CONTRACT CHANGE ORDER

CCO: 69 **Suppl. No. 0** **Contract No. 04 – 0120F4** **Road** SF-80-13.2/13.9 **FED. AID LOC.:**

Eliminate the requirement to pressure test the closed U-ribs stiffeners underneath the steel orthotropic bridge deck. Add capping plates to the diagonal stiffener plates at the BC and CD corners of the tower legs as shown in this change order.

SAN FRANCISCO OAKLAND BAY BRIDGE
EAST SPAN SEISMIC SAFETY PROJECT
SELF-ANCHORED SUSPENSION BRIDGE
(SUPERSTRUCTURE & TOWER)

CAPPING PLATE DETAILS
NTS

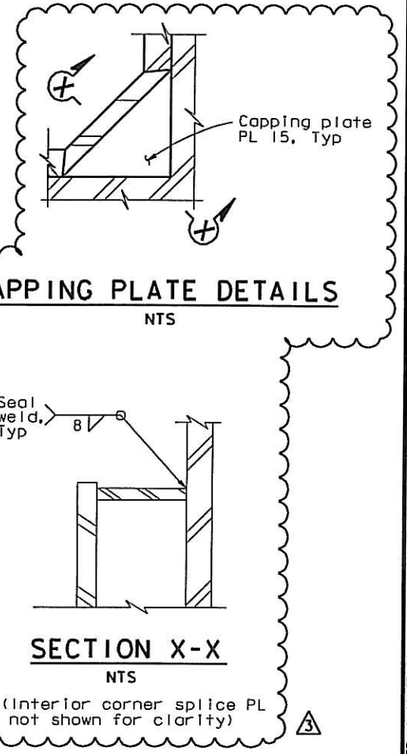
MARK	DATE	DESCRIPTIONS	BY	CH'D	CCO#
3	10/08/08	U-RIB & TOWER CORNER SEALING	MN	NV	69
2	07/25/08	TOWER DOUBLER PLATE & SPLICE CORNER DETAILS	MN	NV	62
1	06/23/06	SPLICE PLATES PER ISM	MN	NV	21

TOWER SPLICE DETAILS NO. 10

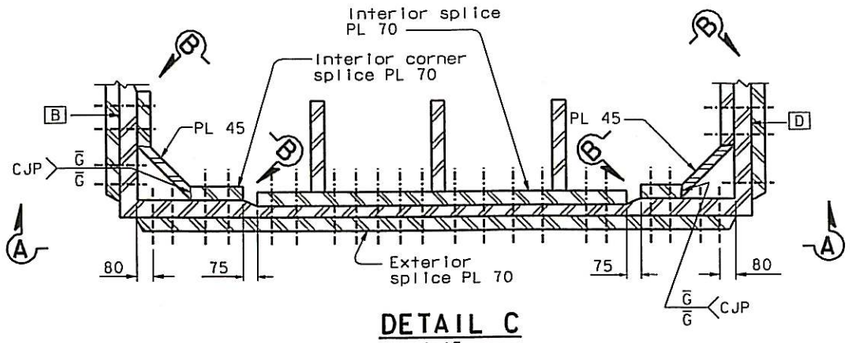
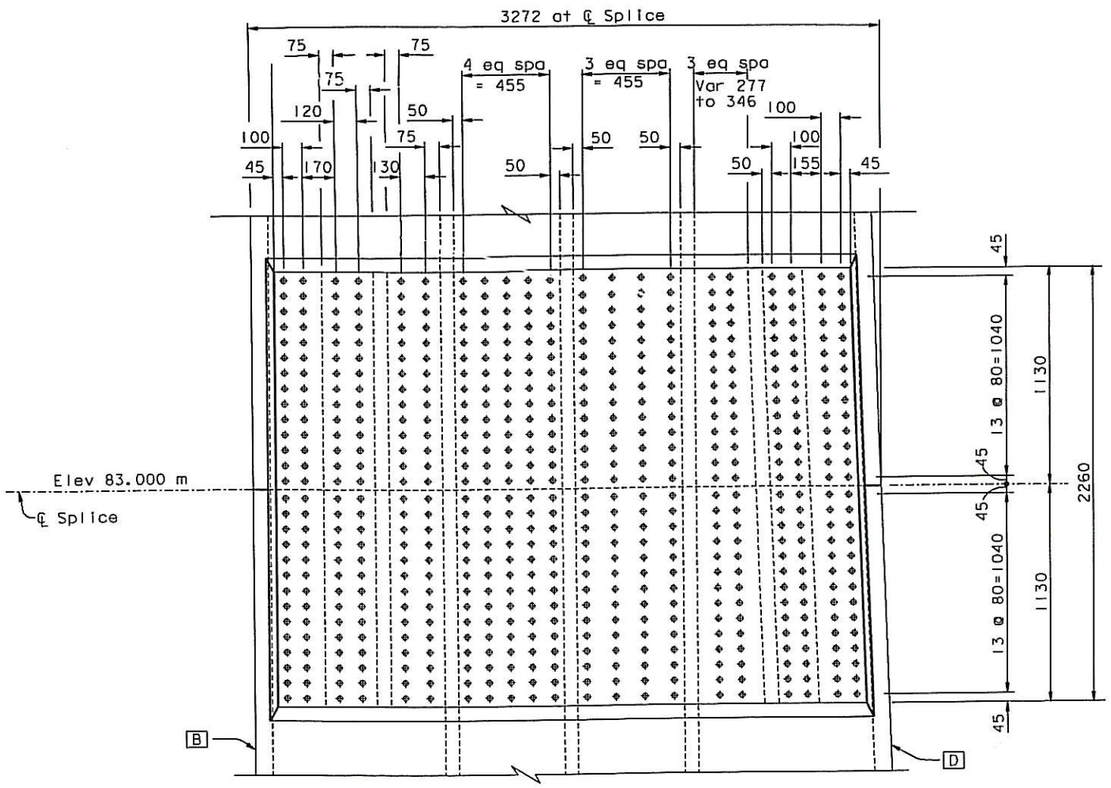
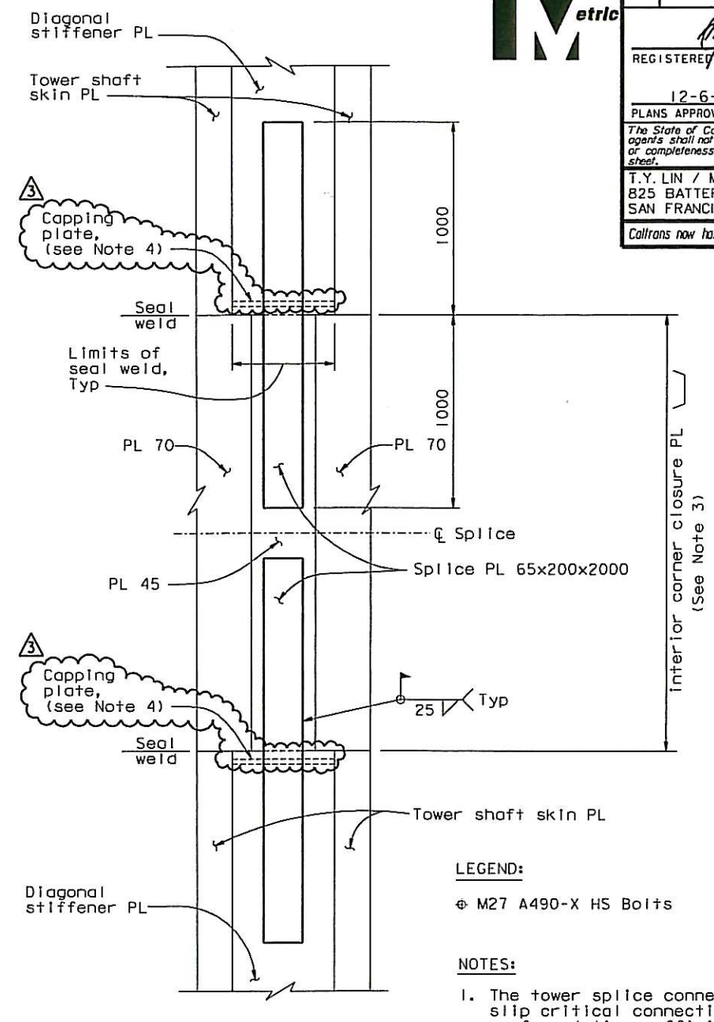
1. The tower splice connections are designed as slip critical connections with class B contact surface (slip coefficient 0.5). The Contractor shall ensure that the flatness requirements at the faying surfaces and the geometry control are met.
2. Elevation view of adjacent skin plate not shown for clarity.
3. The length of the interior corner splice plate shall be adjusted to ensure the 45 mm minimum bolt edge distance (in the vertical direction).
4. (3) For Capping Plate Details, see "Tower Splice Details No.5" sheet.

MARK	DATE	DESCRIPTIONS	BY	CH'D	CCO#
3	10/03/08	U-RIB & TOWER CORNER SEALING	MN	NV	69
2	07/25/08	TOWER DOUBLER PLATE & SPLICE CORNER DETAILS	MN	NV	62
1	06/23/06	SPLICE PLATES PER ISM	MN	NV	21

TOWER SPLICE DETAILS NO. 15

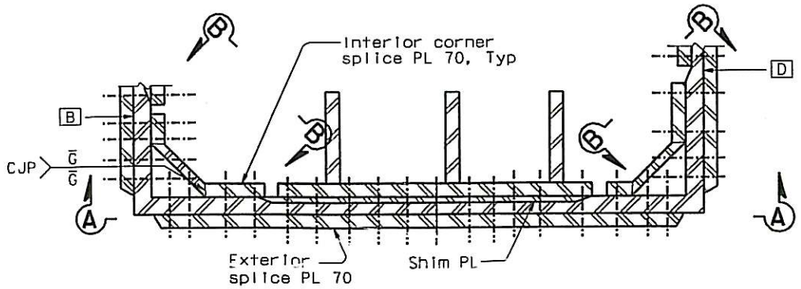
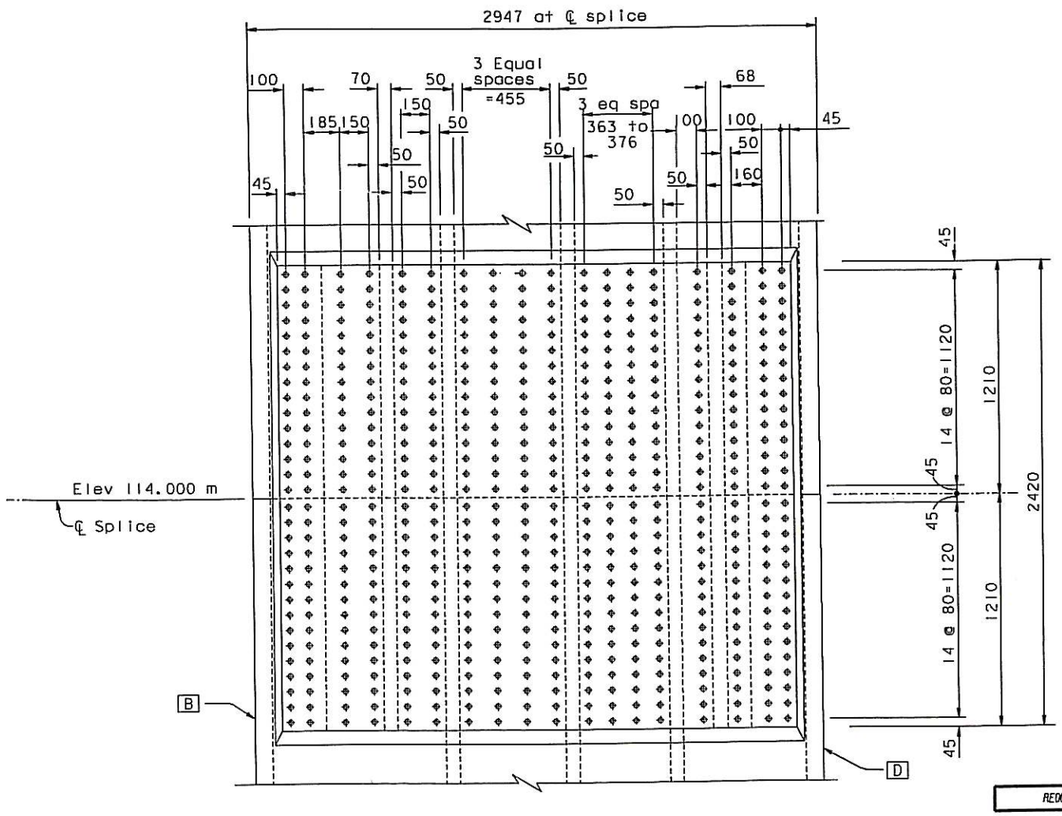
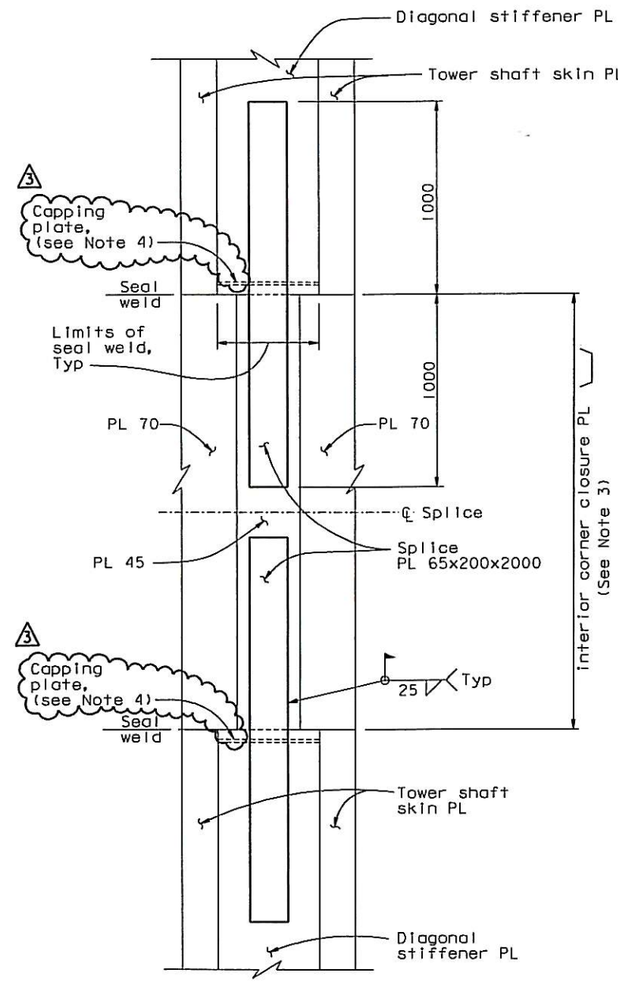
1. The tower splice connections are designed as slip critical connections with class B contact surface (slip coefficient 0.5). The Contractor shall ensure that the flatness requirements at the faying surfaces and the geometry control are met.
2. Elevation view of adjacent skin plate not shown for clarity.
3. The length of the interior corner splice plate shall be adjusted to ensure the 45 mm minimum bolt edge distance (in the vertical direction).
4. (3) For Capping Plate Details, see "Tower Splice Details No.5" sheet.

MARK	DATE	DESCRIPTIONS	BY	CH'D	CCO#
3	10/03/08	U-RIB & TOWER CORNER SEALING	MN	NV	69
2	07/25/08	TOWER DOUBLER PLATE & SPLICE CORNER DETAILS	MN	NV	62
1	06/23/06	SPLICE PLATES PER ISM	MN	NV	21

TOWER SADDLE GRILLAGE DETAILS NO.3

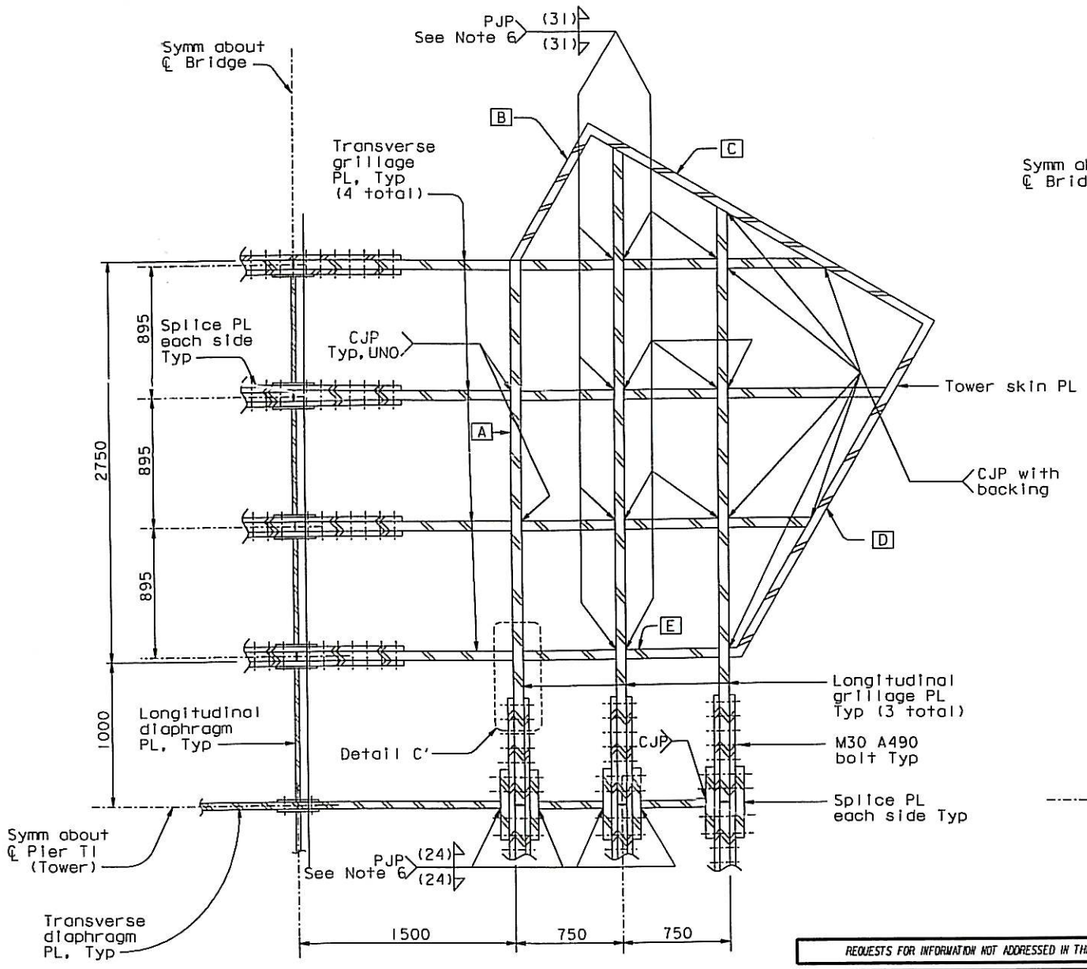
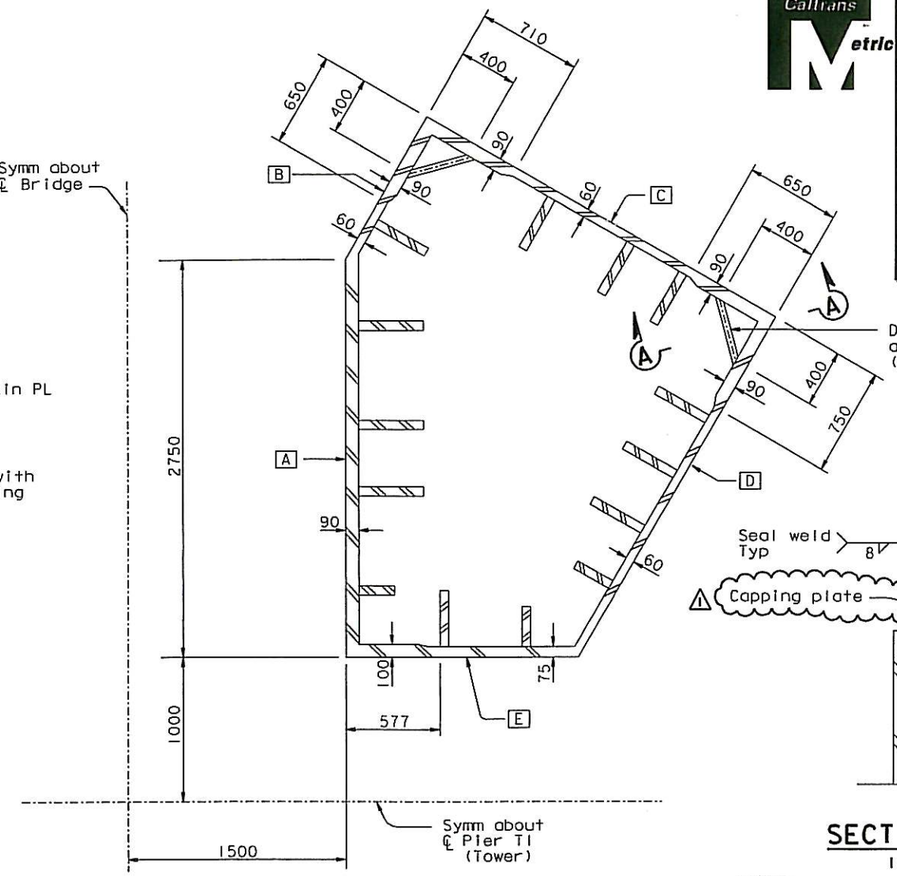
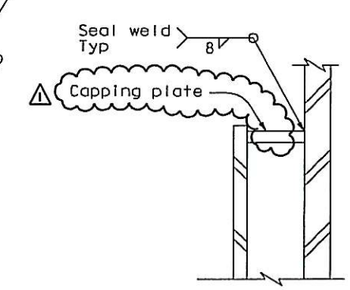
1. See schedule A in conjunction with Detail D for tower PL and stiffener size between elevations 144.000 m and 150.900 m.
2. 1 End of diagonal stiffener shall be sealed with a capping plate with no copes. This detail also applies at the ends of every lift where bolted splices occur at elevations 50.30 m, 83.00 m and 114.00 m. See "Tower Splice Details No.5, No.10 and No.15" sheets.

MARK	DATE	DESCRIPTIONS	BY	CH'D	CCO#
1	10/08/08	U-RIB & TOWER CORNER SEALING	MN	NV	69

TYPICAL GIRDER DETAILS NO. 4

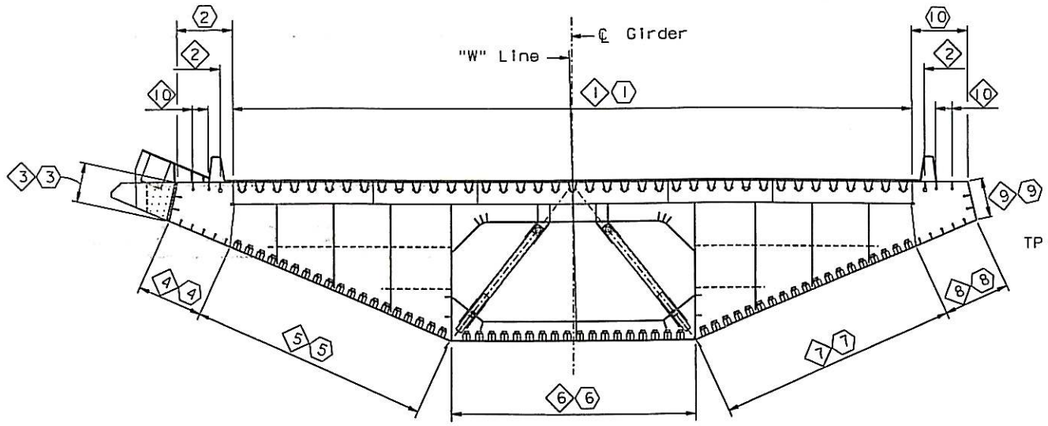
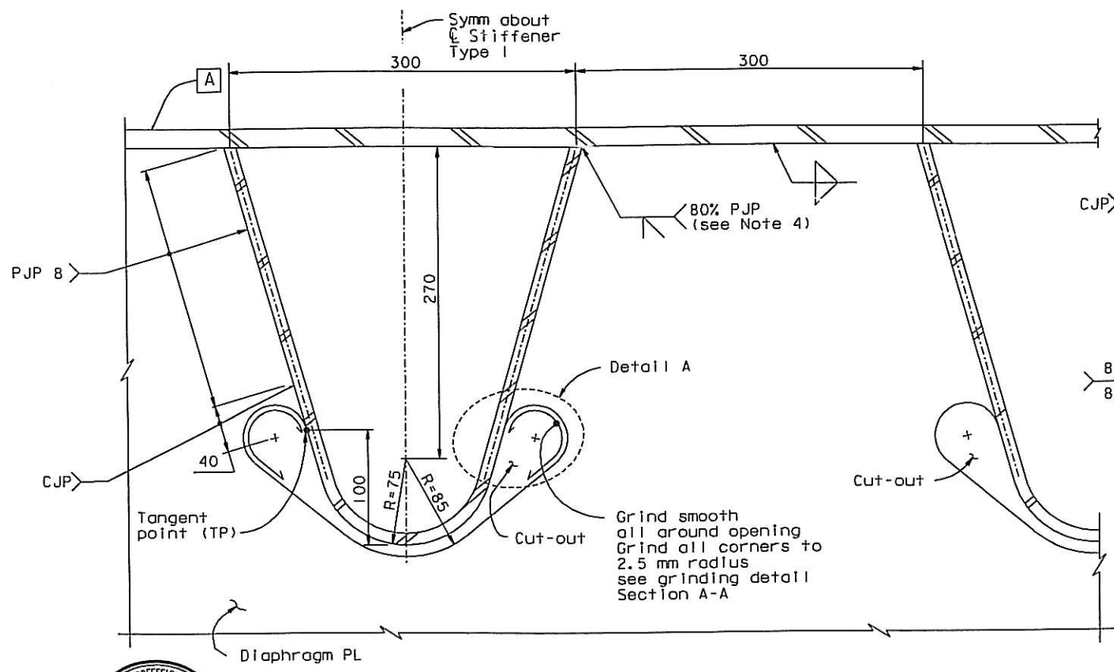
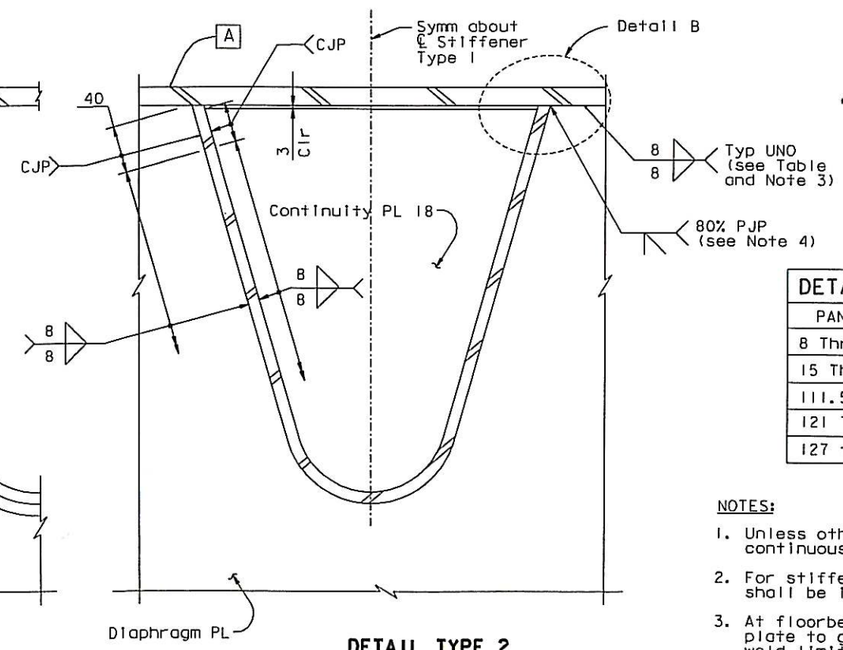
1. Unless otherwise indicated, stiffener type 1 is continuous through floorbeam diaphragm plate.
2. For stiffener type 1, finish surface of cut-out shall be in accordance with ANSI 500 roughness.
3. At floorbeam cable opening, weld of diaphragm plate to girder Plate A shall be CJP. For CJP weld limits, see "Floorbeam At East Transition" sheets.
4. Closed ribs shall be sealed with diaphragm. See Diaphragm Detail on "Typical Girder Details No. 11" sheet.

MARK	DATE	DESCRIPTIONS	BY	CH'D	CCO#
1	10/03/08	U-RIB & TOWER CORNER SEALING	DT	NV	69
